COLUSA COUNTY Airport Advisory Committee SPECIAL MEETING AGENDA

August 12, 2021

Request For Airport Advisory Committee

SUBJECT: Golden Roots Nursery (Ranveer Tumber) Greenhouse (Hoop Houses) Project

Exhibit A

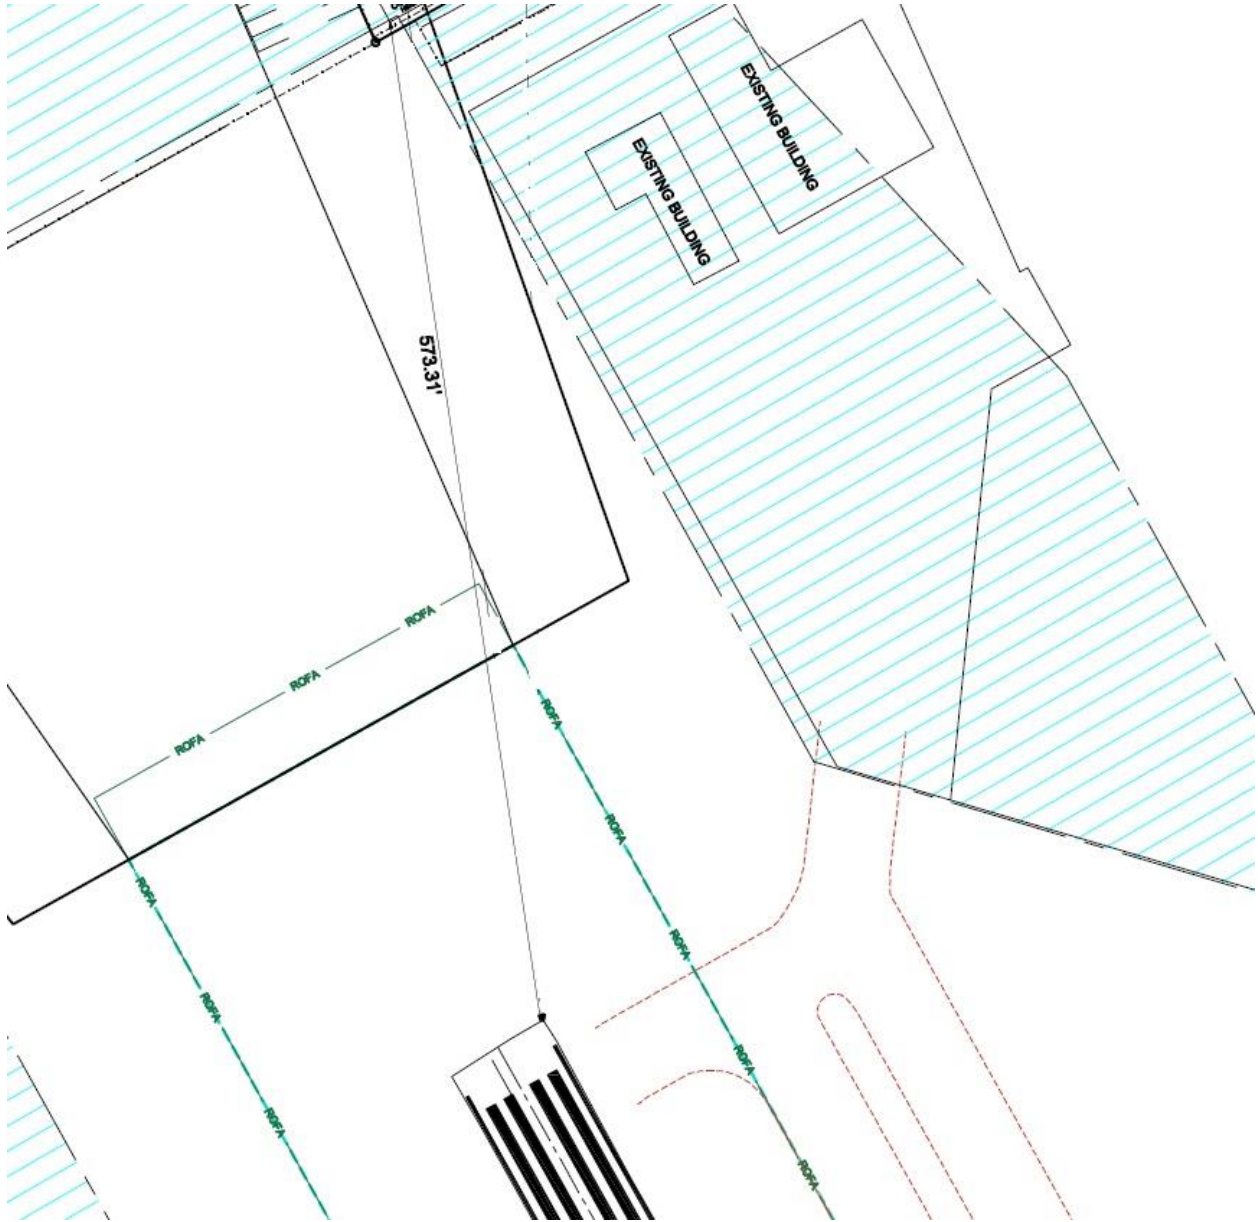
Highest elevation in proposed area is 48.20'. Highest Point on runway has an elevation of 49.60' per NAVD 88 as shown on exhibit 4B of the Colusa County Airport Layout Plan. Therefor we are 1'+ below grade at this location.

We are approx. 573' from the edge of the runway to the corner of the property closest to the runway. At a 50:1 slope this gives us 11.46". Being below grade, it gives us an additional 1 foot, totaling 12.46" of allowed height.

Our Structures at 9' will be 3+ plus feet (closer to 4') below the maximum allowed height.

Aggregate Wattage Calculation Per Greenhouse

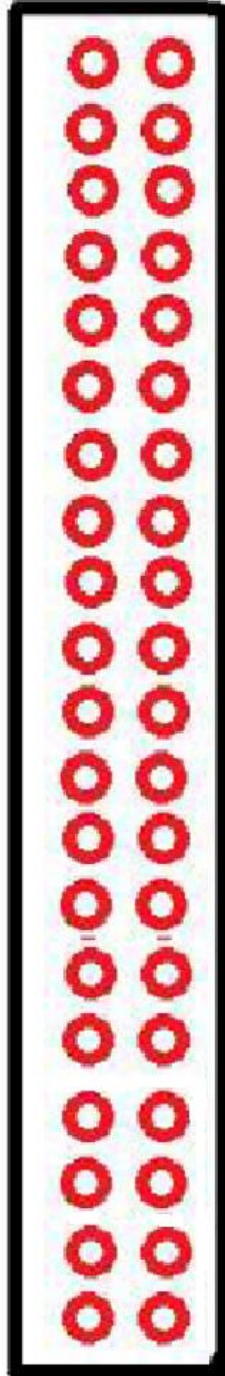
Greenhouse lighting will be low intensity LED Lighting. String lights with Flood light bulbs will be used. These lights will have a downward beam of 60 degree. Downward lighting will not allow light to hit the ceiling of the building, therefor avoiding any upward lighting glare. Lighting will be used to supplement daylight hours giving 24 hours of illumination. Lights will be 1.41 watts per sq ft.

We are not using High Intensity Discharge lights or any gas discharge lights such as High Pressure Sodium. These lights are used for cannabis flowering and are associated with high glare. HID lights are used at a rate of 41.66 watts per sq ft.

The applicant has provided a lighting plan (Exhibit B) which details that the greenhouses will be illuminated with low intensity LED lighting. The string lights will be oriented downward with a 60 degree beam as to not create glare outside of the proposed hoop houses. The lights will be used to supplement daylight so they receive 24-hours of illumination. There will be 160 lights (40 per greenhouse) which will use 85 watts of electricity each for a total of 13,600 watts, with the greenhouse complex covering 9,600 square feet this results in 1.4 watts per square foot. For comparison High Intensity Discharge Lighting (HID) used for flowering of plants average 41.66 watts per square foot. There will be no additional exterior security lighting and the greenhouse plastic will coated in light diffusing materials. The proposed lighting system is essentially the same as was found to be consistent with ACLUP under the ALUC 21-01 application which was reviewed in March of this year.

2. At the August 12, 2021 meeting, the Commission found that the proposed greenhouse complex was consistent with the Airport Land Use Compatibility Plan contingent on the condition that the proposed greenhouse complex shall be constructed in accordance with the proposed building plans detailed in Exhibits "A" and "B" attached to the August 12, 2021 staff report which calls for the use of opaque light diffusing materials on the greenhouse roofs and siding, that the proposed lighting utilize the low-intensity lighting, and that any exterior lighting be shielded and directed downward to reduce light and glare to the satisfaction of the Community Development Director.

Exhibit "B"

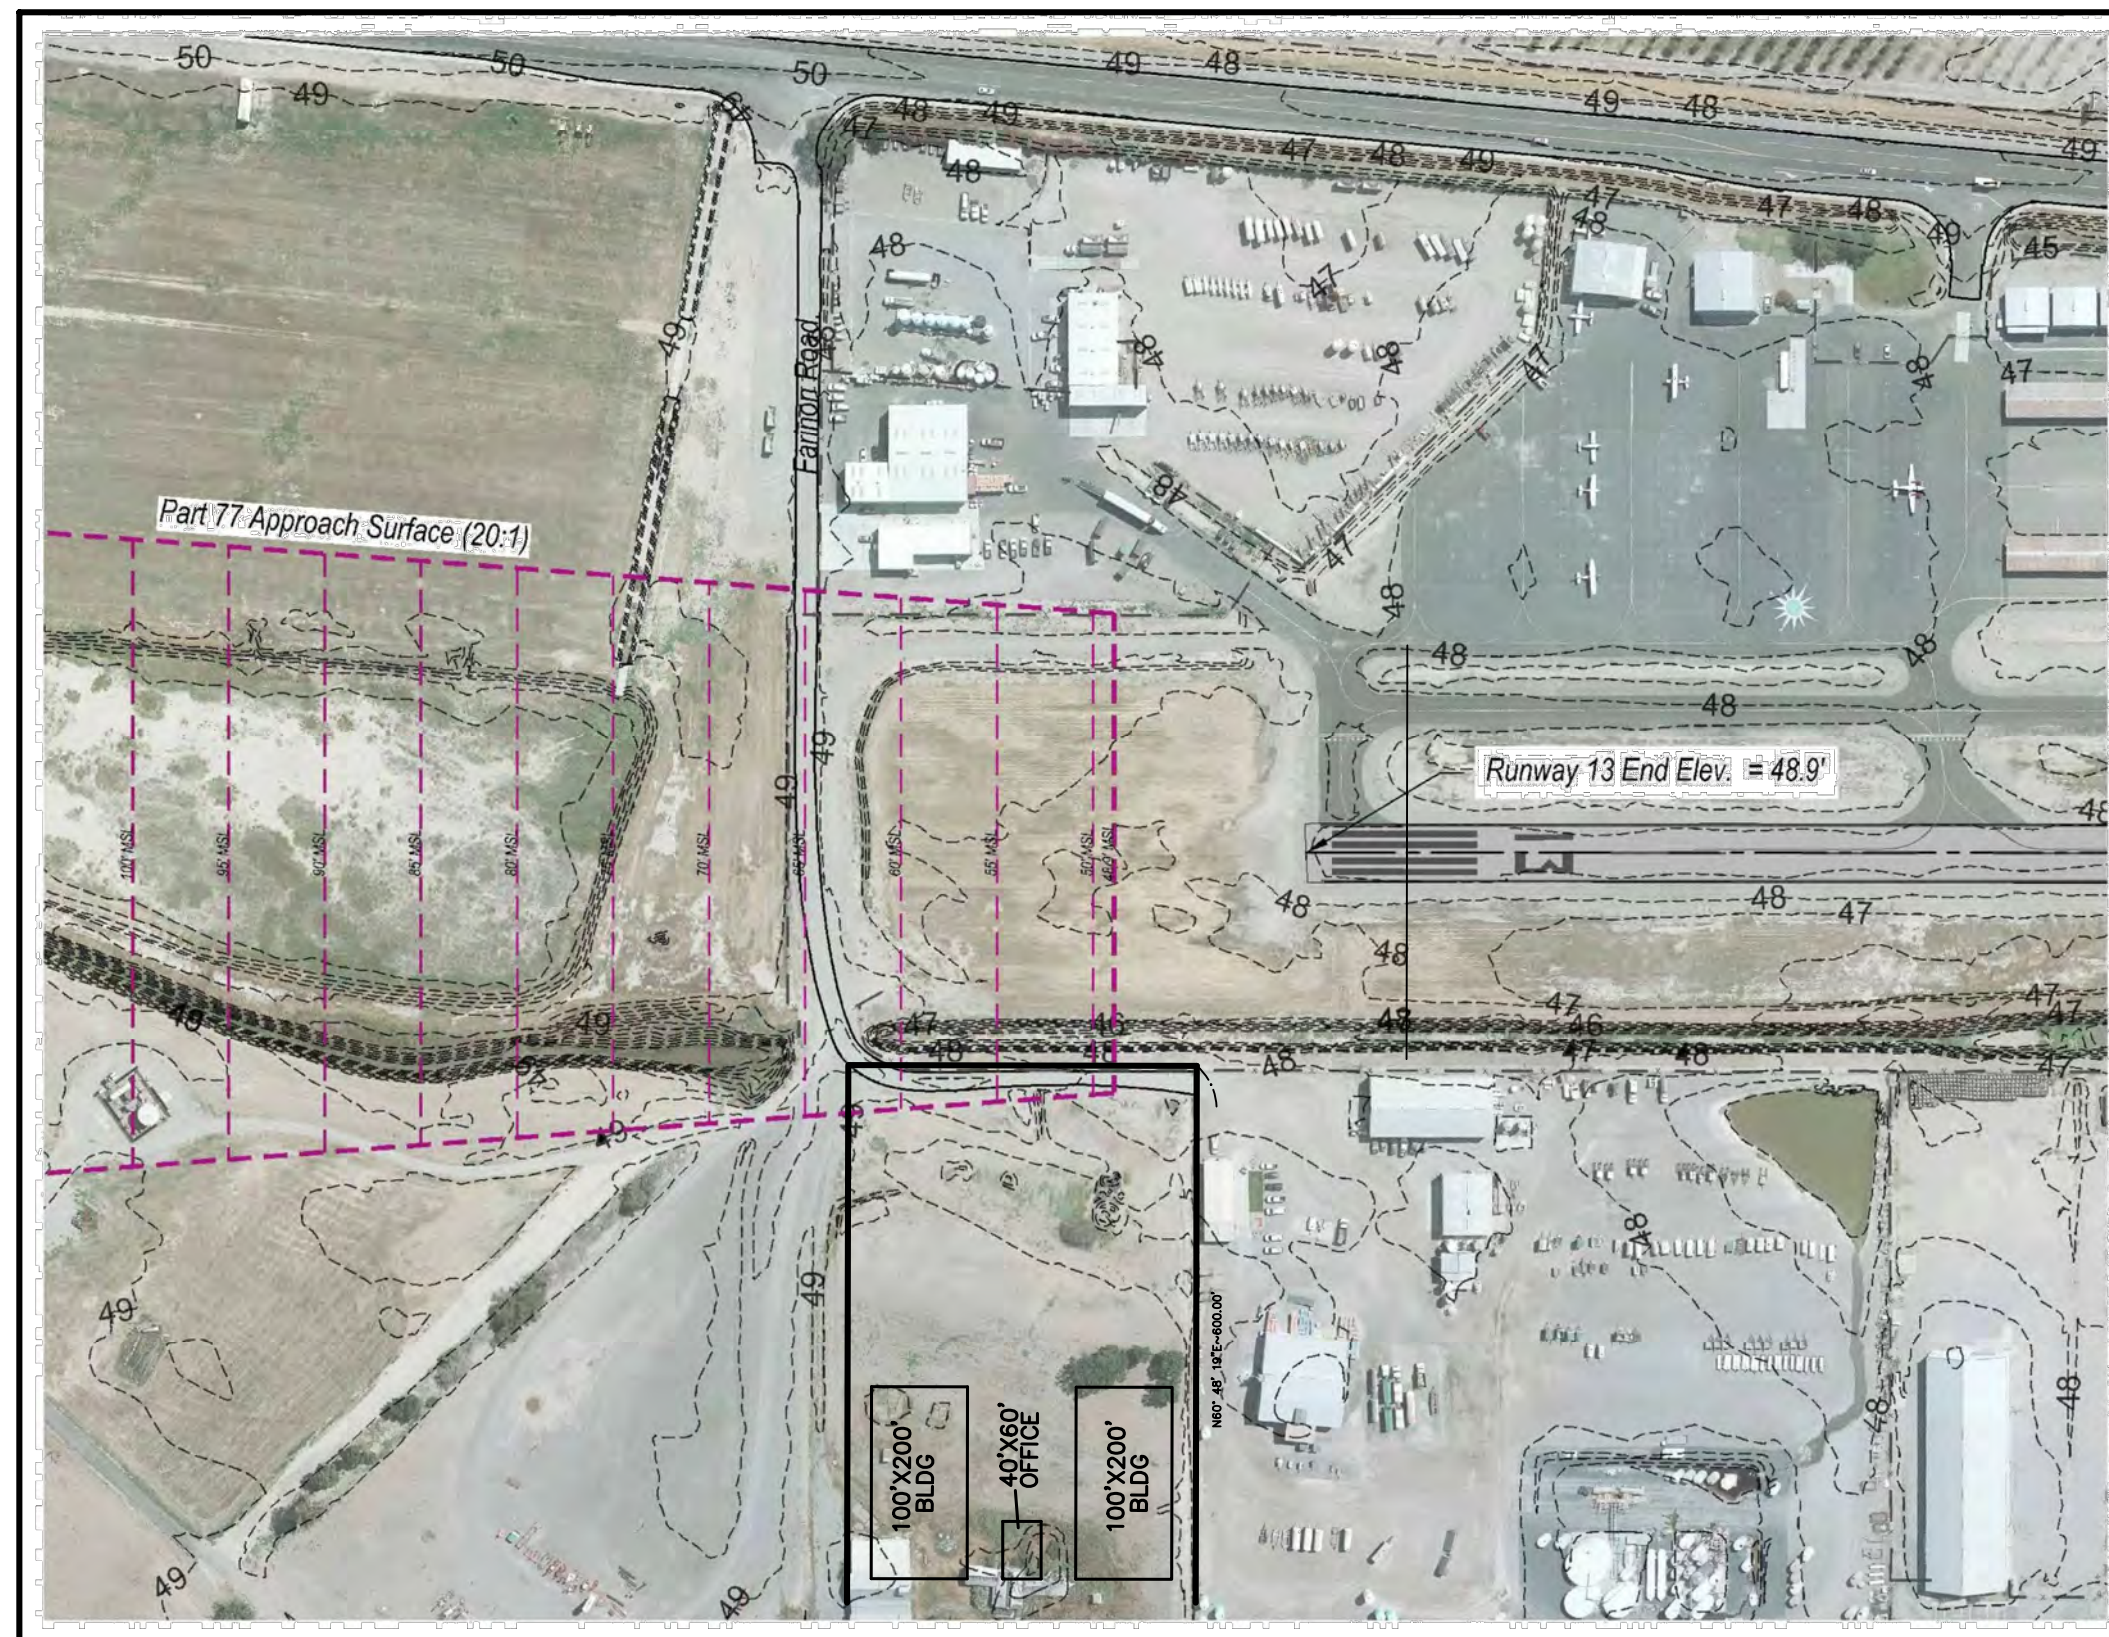
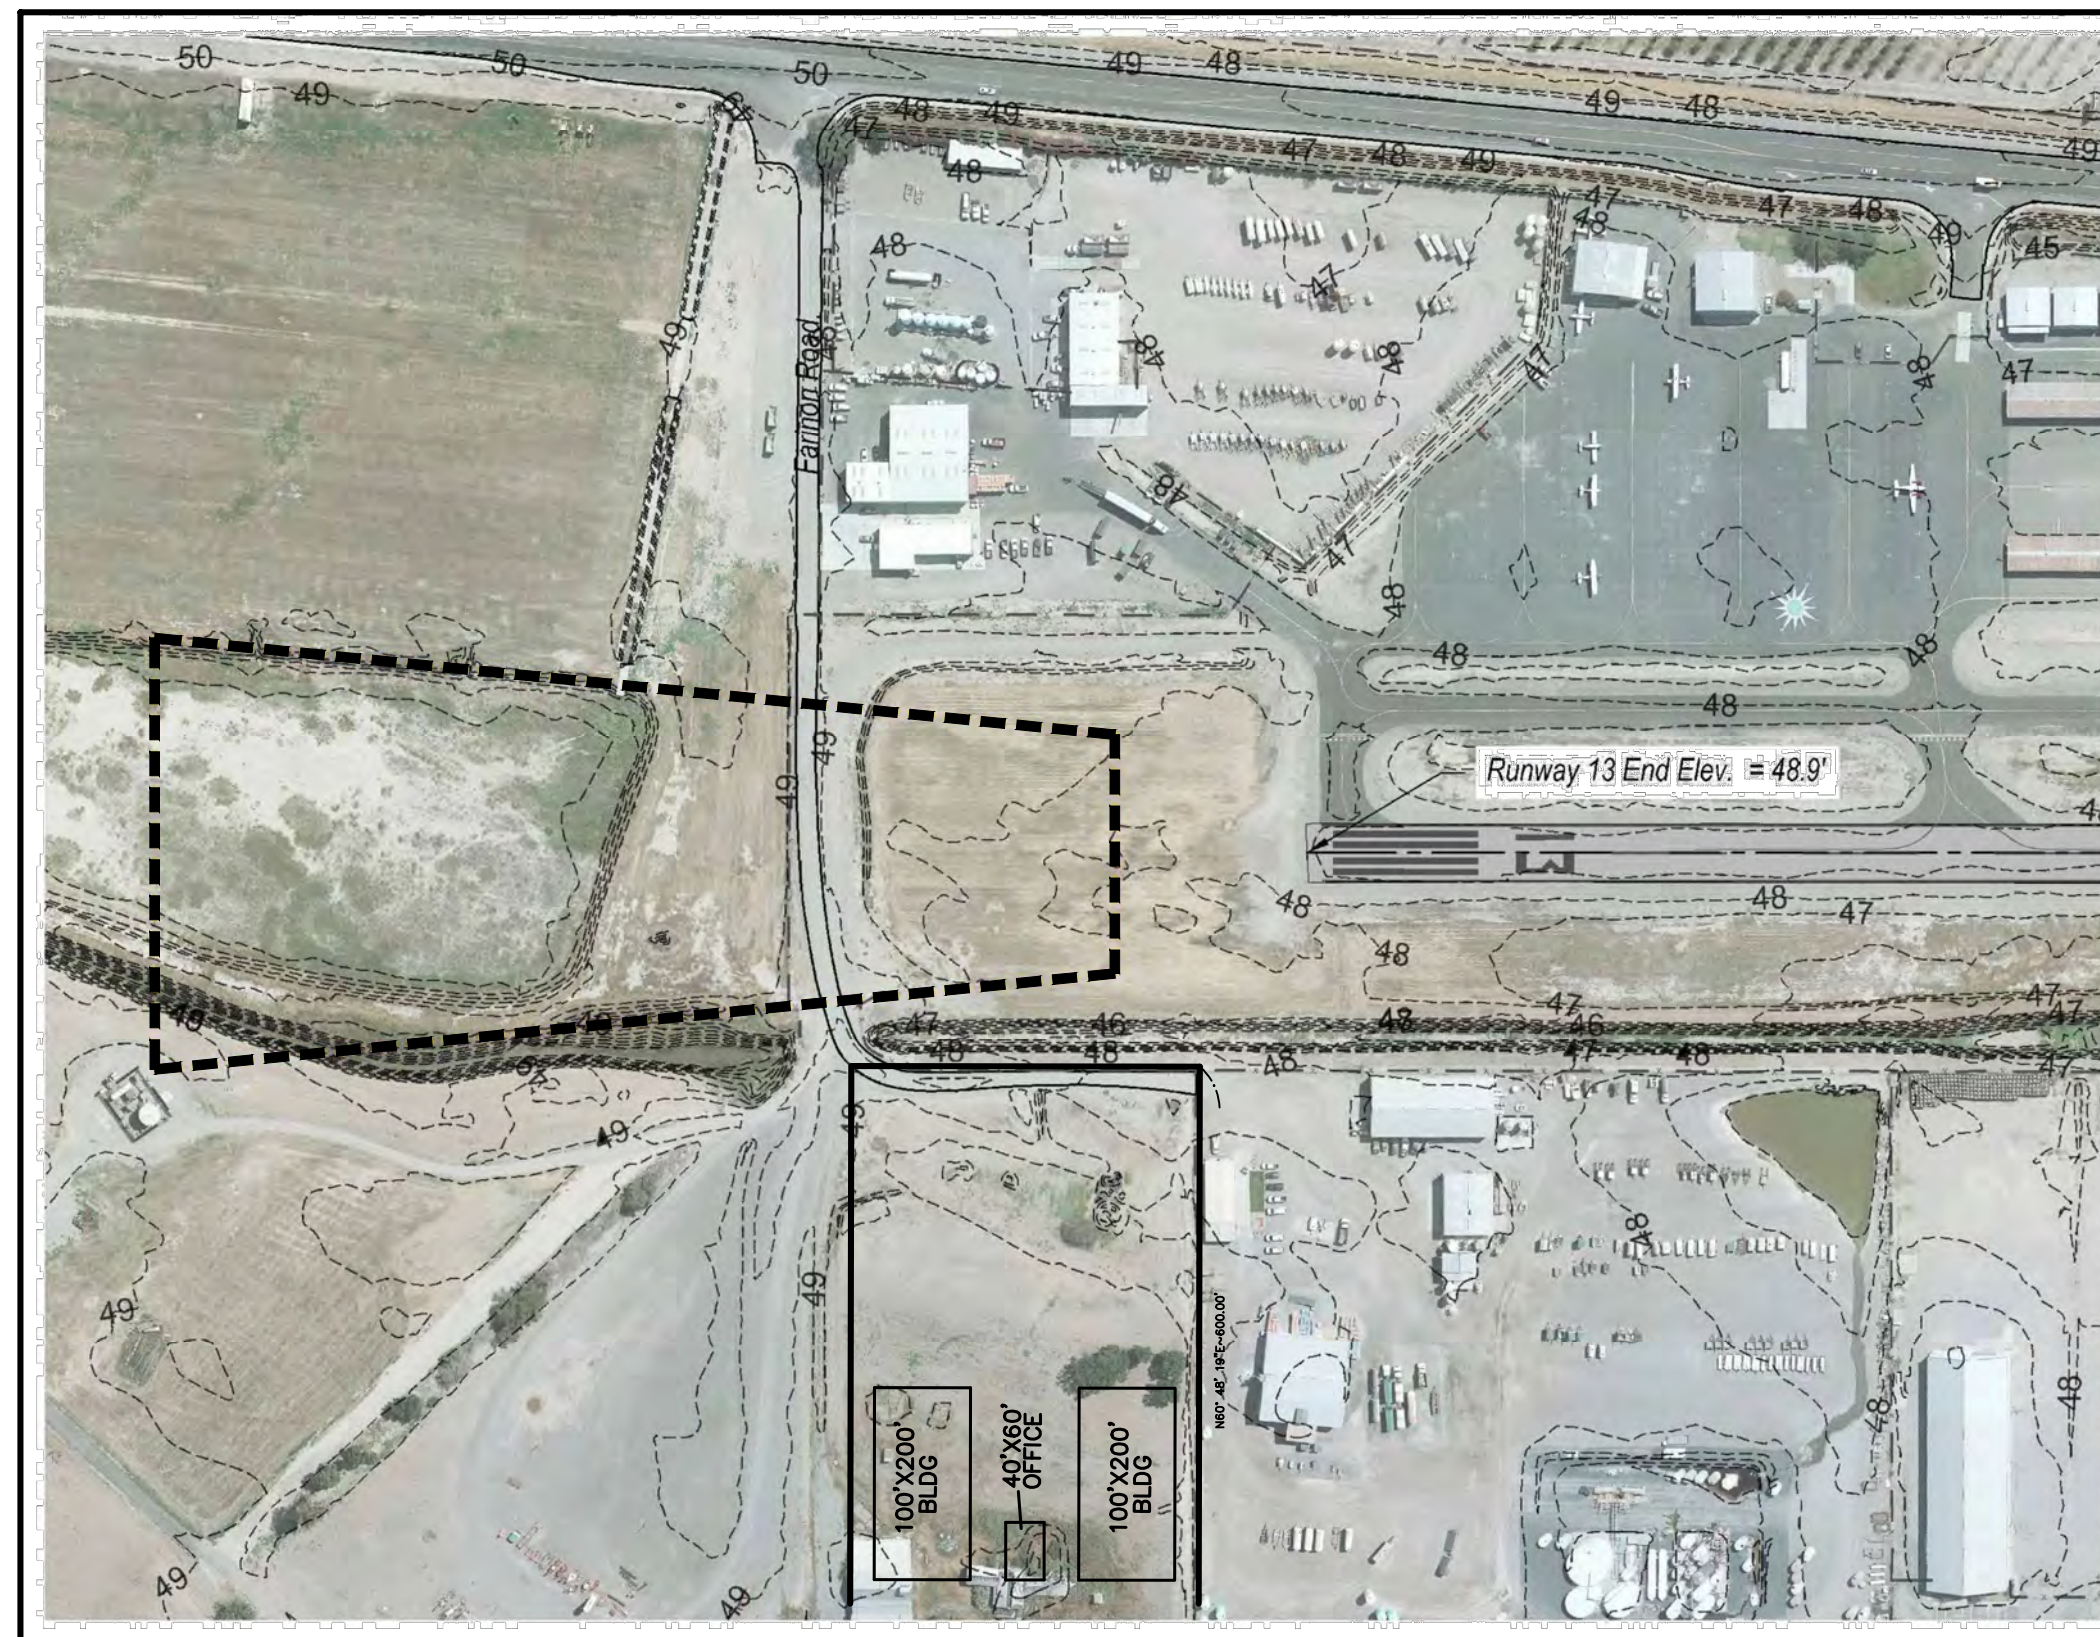
Exhibit "B" shows that the subject site is located in the ALUCP's B1 and C1 Compatibility Zones. As shown in Exhibit "C" (Site and Building Plans), the industrial buildings would be located on the westerly half of the parcel in Zone C1 and the outdoor storage and truck parking would be located on the easterly half of the parcel in Zone B1. The proposed use within the buildings would be considered a "Light Industrial - Low Intensity" use and it is a permitted use in the C1 Zone. Examples of Light Industrial - Low Intensity uses include wood product facilities with a person density of less than 350 sq.ft. per person and does not include the storage of hazardous materials. The proposed use meets these criteria. The proposed use would have outdoor storage in the B1 Zone which is also permitted use, provided an airspace obstruction does not occur (the airspace discussion follows under the height section).

Given the degree of the building encroachments into the various regulated height elevations, staff believes that the information from the FAA's hazard determination should be considered prior to a formal building height consistency determination being made. The Commission could provide an initial consistency determination for issues where the necessary information has been provided that allows for issues to be fully analyzed. However, for issues such as building height where a critical piece of information is not yet available, staff does not believe a formal determination either for or against can be made with any degree of certainty.

7. The property is located within the Airport's Critical Airspace Protection Zone (ALUCP Map 3B, Airspace Protection Surfaces). Project proponents have submitted conceptual plans for two buildings in the easterly half of the property to the FAA for a hazard identification study. The results of the conceptual FAA Aeronautical Study No. 2021-AWP-2877-0E and Aeronautical Study No. 2021-A WP-2883-0E is that objects that exceed a height as little as three feet could penetrate an Airspace Protection Zone.
